# Stage 05: Final Self-Governance Report

# GC0110: LFSM-O compliance requirements for Type As and B PGMs

**Purpose of Modification:** To update the Grid Code and G99 with revised text for *limited frequency sensitive mode- over-frequency* compliance so that manufacturers have clear pass/fail criteria for limited frequency sensitive mode-over-frequency compliance.

Figure 1 - +2.0Hz injection with 10% droop setting (initial response)

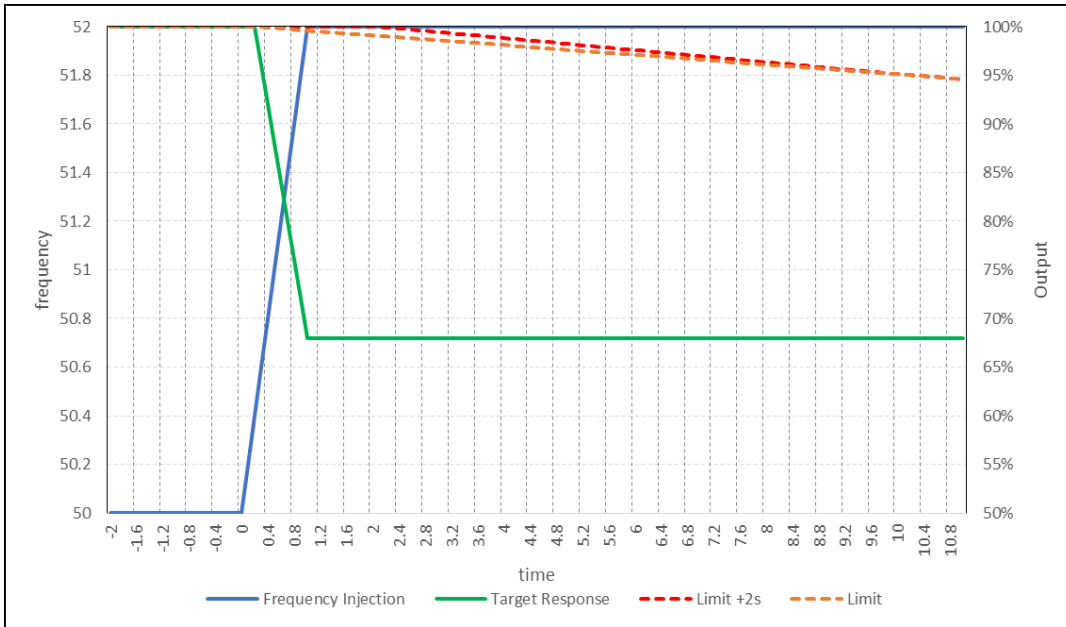
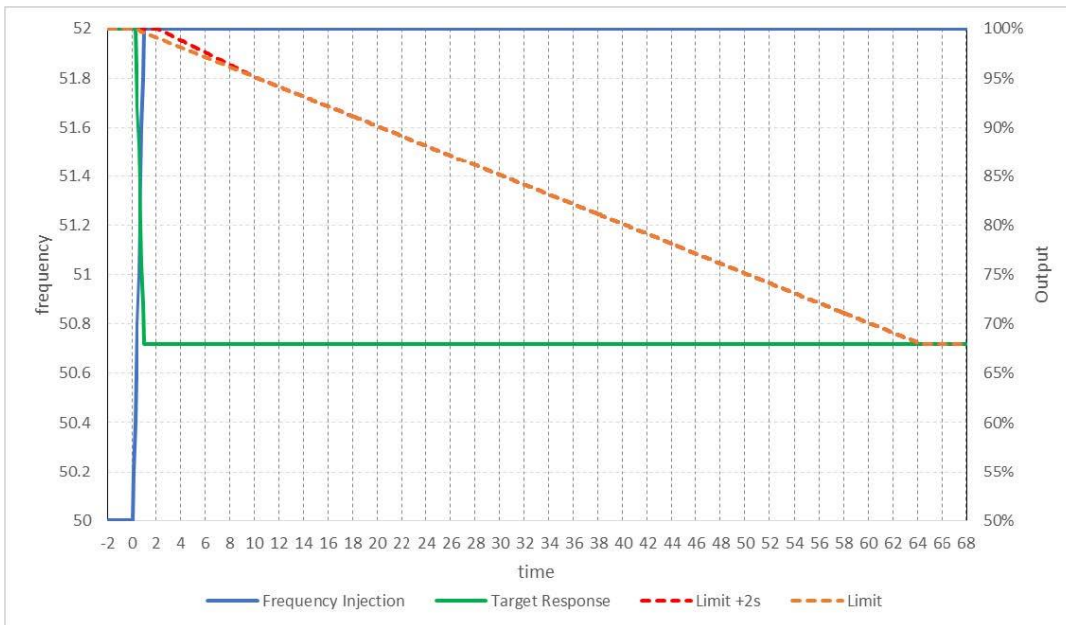
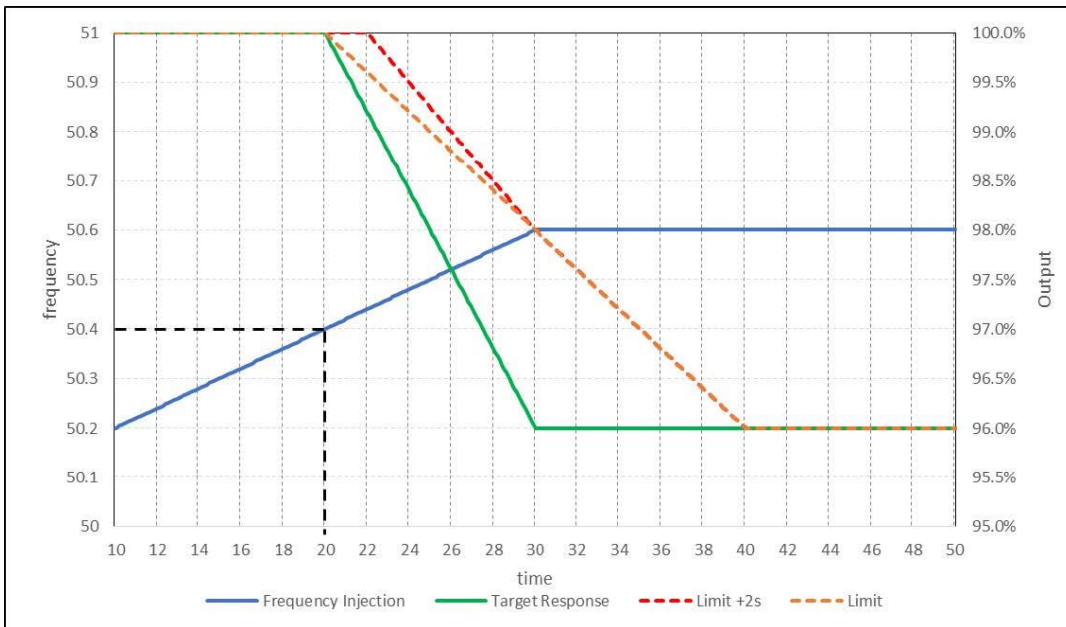
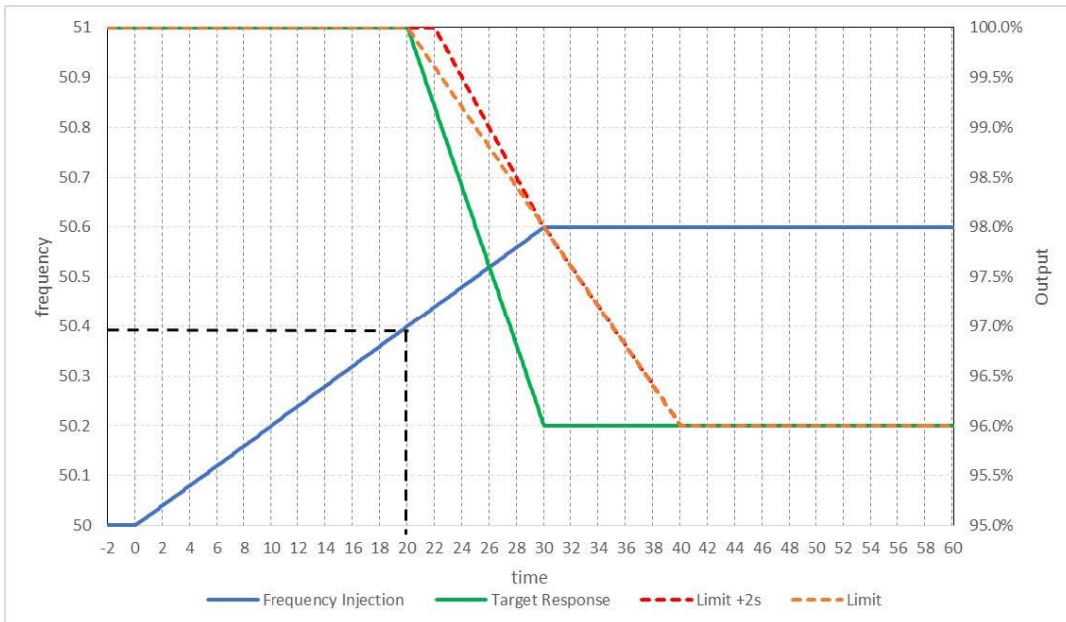
This is indicated graphically for an injection of a +2.0Hz step (as a 1 second ramp) in figures 1 & 2 and for an injection of a +0.6Hz ramp in figures 3 & 4. On the graphs the blue line indicates the injected frequency with the green line

The Work group also discussed whether the permitted 2 second delay in starting to respond to a frequency change should be allowed to apply after the 10 second activation period and hence change the red lines in figures 1,2,3 and 4 to be parallel to the orange line and not coincide after 10 second. After discussion it was agreed the current interpretation with the lines coinciding after 20 seconds as per the proposal is acceptable.

Therefore interpreting “as much as possible” of the change in 10 seconds National Grid, suggests a value of 50% of the steady state change is achieved in 10 seconds but noting that the requirement continues for larger frequency this should be capped at a maximum of 5% of maximum output as an acceptable level of a fast acting contribution. The proposed values of the minimum response to a frequency change in 10 second are given in the fourth column of table 1.

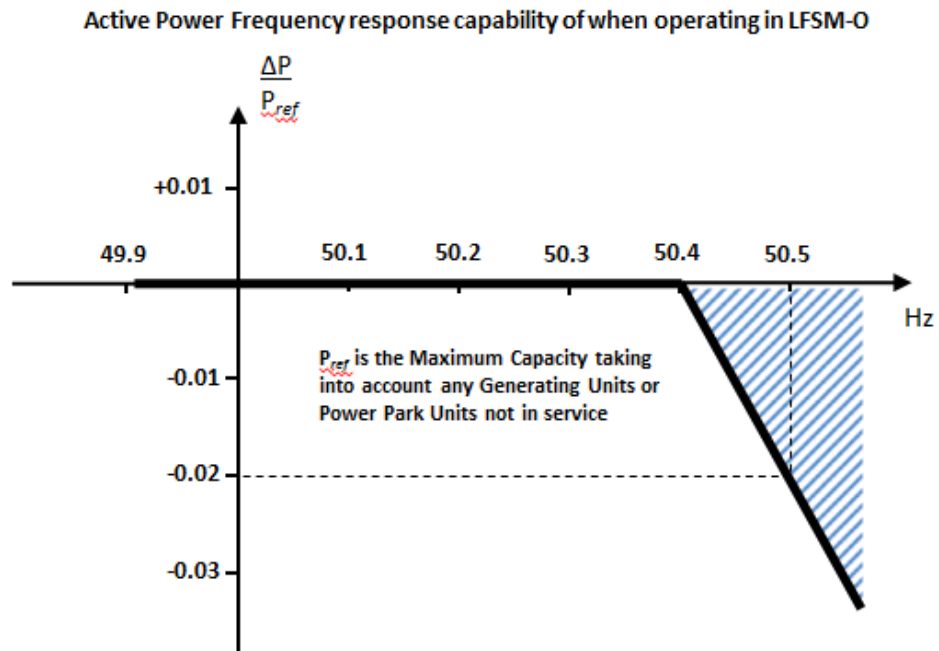
- ECC.6.3.7.1.2
- (i) The rate of change of **Active Power** output must be at a minimum a rate of 2 percent of output per 0.1 Hz deviation of **System Frequency** above 50.4Hz (ie a **Droop** of 10%) as shown in Figure ECC.6.3.7.1 below. This would not preclude a **EU Generator** or **HVDC System Owner** from designing their **Power Generating Module** with a **Droop** of less than 10% but in all cases the **Droop** should be 2% or greater.

- (iii) As much as possible of the proportional reduction in **Active Power** output must result from the frequency control device (or speed governor) action and must be achieved within 10 seconds of the time of the **Frequency** increase above 50.4 Hz. The **Power Generating Module** (including **DC Connected Power Park Modules**) or **HVDC Systems** shall be capable of initiating a power **Frequency** response with an initial delay that is as short as possible. If the delay exceeds 2 seconds the **EU Generator** or **HVDC System Owner** shall justify the ~~delay~~variation, providing technical evidence to **NGET**.

Figure 1 - +2.0Hz injection with 10% droop setting (initial response)

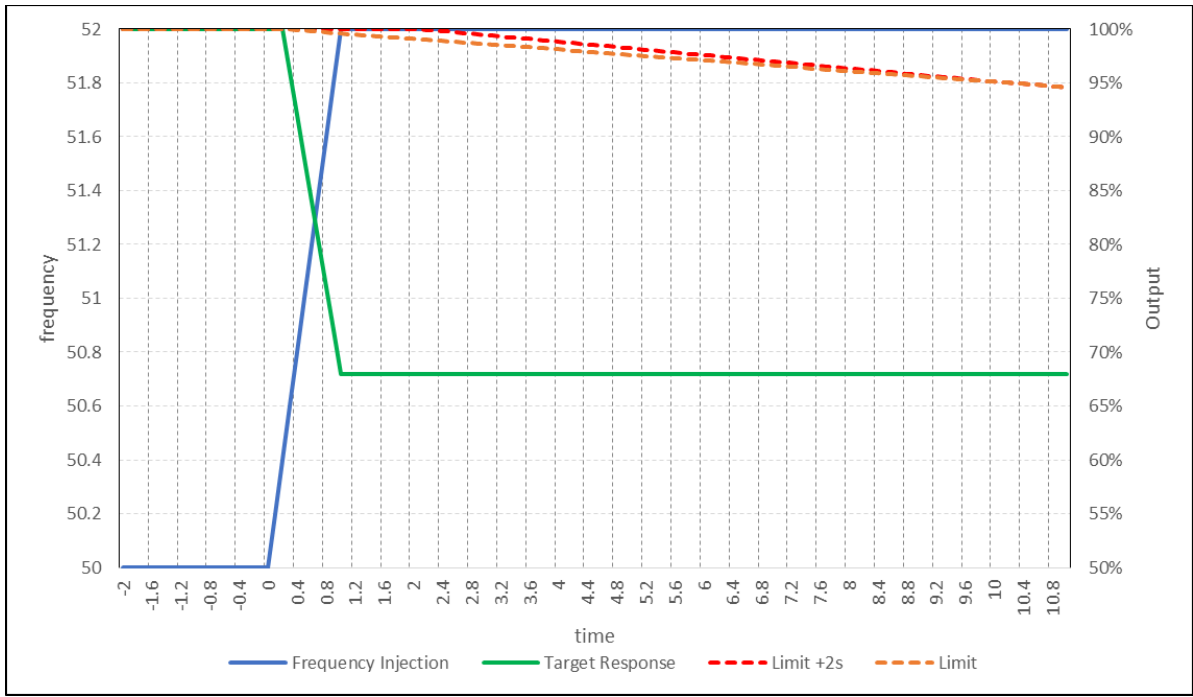
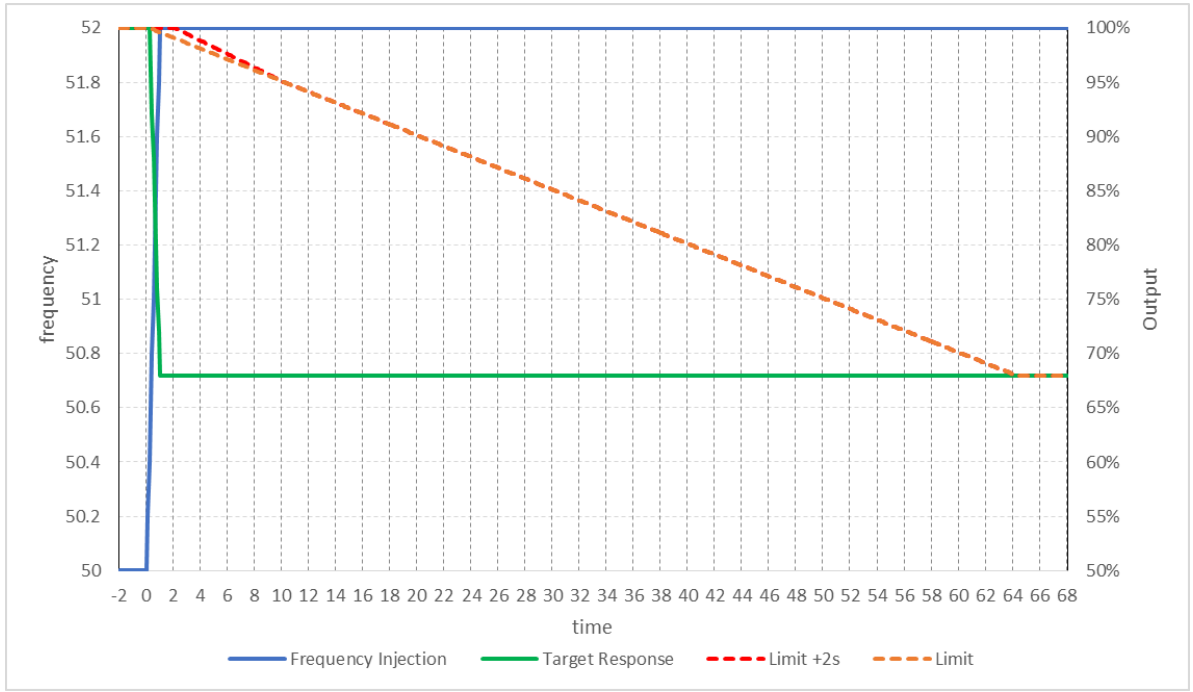
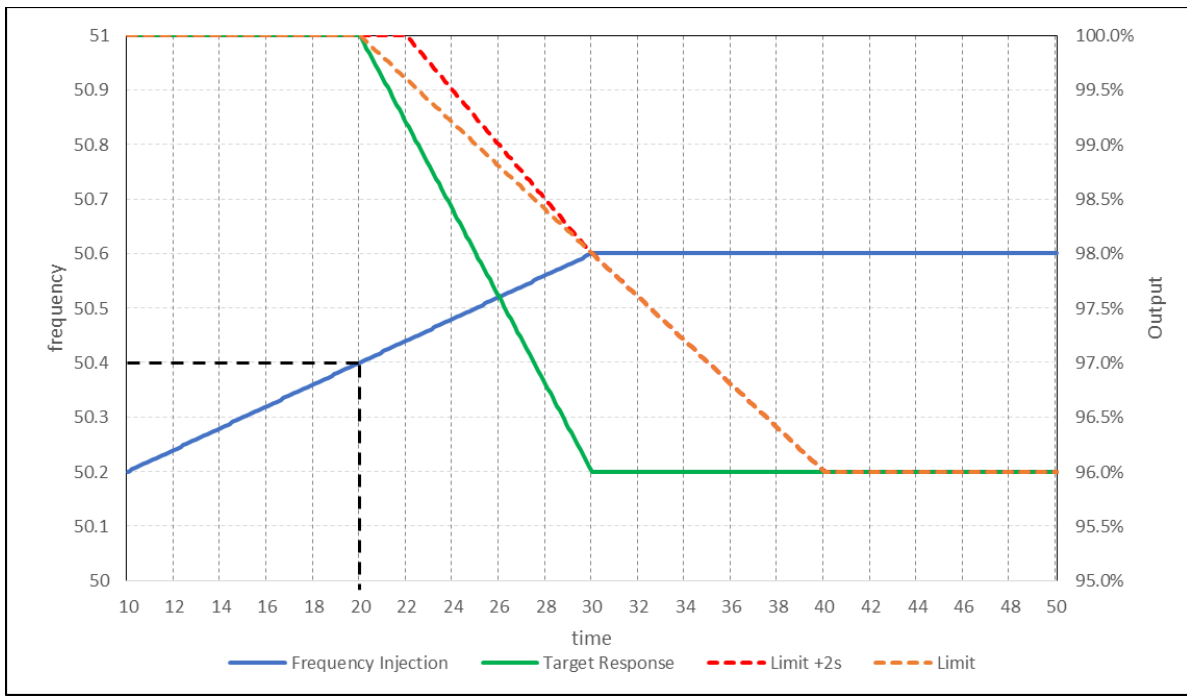
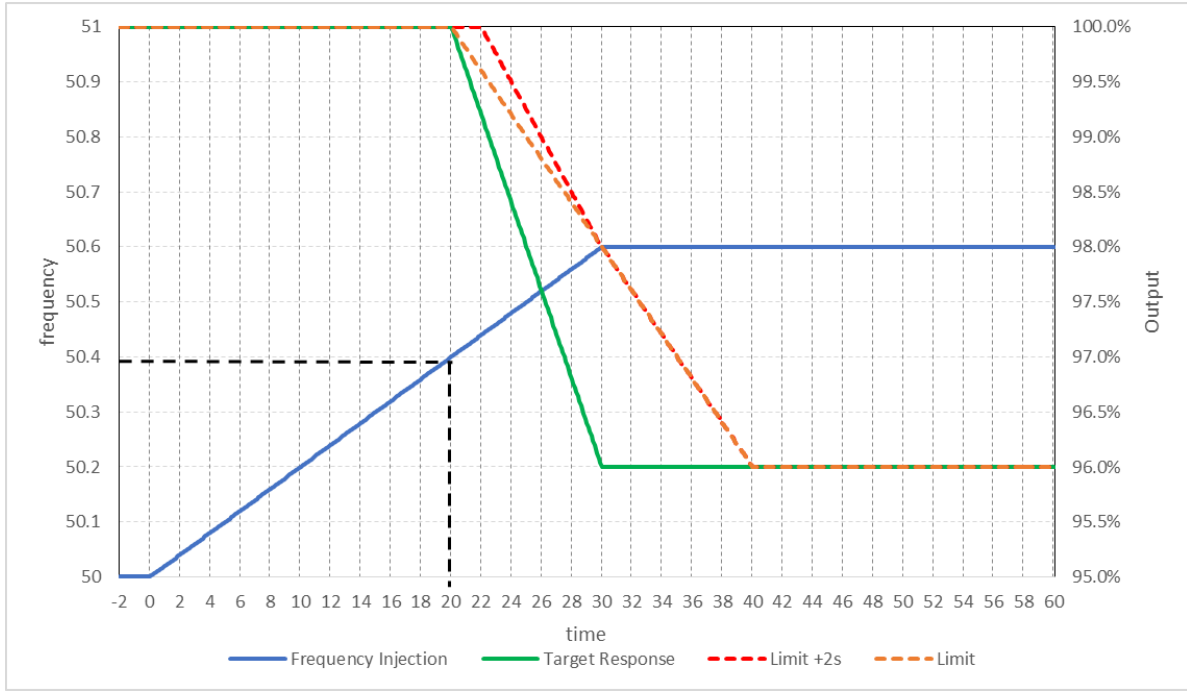
This is indicated graphically for the +2.0Hz step and +0.6Hz ramp injections in the following figures with the green lines indicating the calculated response position in relation to the frequency deviation The red dashed line indicates the boundary of acceptable response in line with the interpretation set out above. The difference between the orange and red lines indicates the permitted two second delay in for the initial measureable response but it is important to note that at the end of the time period (ie at 10seconds) both the red and brown lines converge to the same point..

Therefore interpreting “as much as possible” of the change in 10s NG, suggests a value of 50% of the steady state change is achieved in 10 seconds but noting that the requirement continues for larger frequency this should be capped at a maximum of 5% of maximum output as an acceptable level of a fast acting contribution.
